Access Compliance Report

Public Rights-of-Way

(Curb Ramps)

Intersection ID: N/A	Main Street: CANTERBURY CASTLE DR	Cross Street: BELVEDERE CASTLE DR	Location: SE
ADA ID: FE4CEA4CBD82	Ramp Type: Perp	Initial Pass/Fail: Fail	Overall Compliance: No
Severity Score: 12.5			
Codes/Mitigation Info/Possible Solution		Field Measurements/Component Compliance

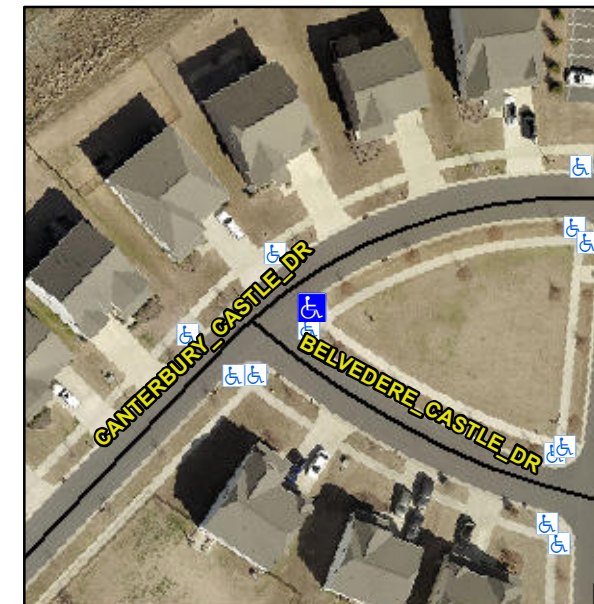
Compliance	Description	Data	Compliance	Description	Data
N/A	Ramp Length (in)	97.0	No	Ramp Slope (%)	8.4
Yes	Ramp Width (in)	48.0	Yes	Ramp XSlope (%)	0.5
N/A	Flare Type LT	N/A	N/A	Flare Type RT	N/A
N/A	Flare Slope LT (%)	N/A	N/A	Flare Slope RT (%)	N/A
N/A	Flare Traversable LT?	N/A	N/A	Flare Traversable RT?	N/A
N/A	Landing Length (in)	N/A	N/A	DWS Provided?	N/A
N/A	Landing Width (in)	N/A	N/A	DWS Contrast?	N/A
N/A	Landing Slope (%)	N/A	N/A	DWS Length (in)	N/A
N/A	Landing X Slope (%)	N/A	N/A	DWS Full Width?	N/A
N/A	Landing Curb? (Y/N)	N/A	N/A	DWS Offset (in)	N/A
N/A	Shared Landing?	N/A			
N/A	Gutter Ponding?	N/A	N/A	Gutter Slope (%)	N/A
N/A	Gutter Lip Ht (in)	N/A	N/A	Gutter X Slope (%)	N/A
N/A	Painted X Walk1?	No	N/A	Painted X Walk2?	N/A
	X Walk 1 Direction	To NW		X Walk 2 Direction	N/A
N/A	X Walk 1 Width (in)	N/A	N/A	X Walk 2 Width (in)	N/A
	X Walk 1 Slope (%)	1.2		X Walk 2 Slope (%)	N/A
	X Walk 1 X Slope (%)	1.4		X Walk 2 X Slope (%)	N/A

Remove & Replace Entire Ramp.
